UNITED STATES PATENT AND TRADEMARK OFFICE

APPLICATION NO.	FILING DATE	FIRST NAMED INVENTOR	ATTORNEY DOCKET NO.	CONFIRMATION NO.
09/912,285	07/24/2001	George A. Teacherson		5196

Office Action Summary

DETAILED ACTION

Fig. 1

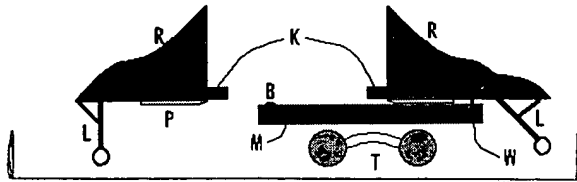
Figure 1 should be grouped together as shown in the supplied marked copy of the drawings or else every figure in the drawings should be labeled separately. Similar grouping is needed for figs. 2, 6, 8, 11, 17.
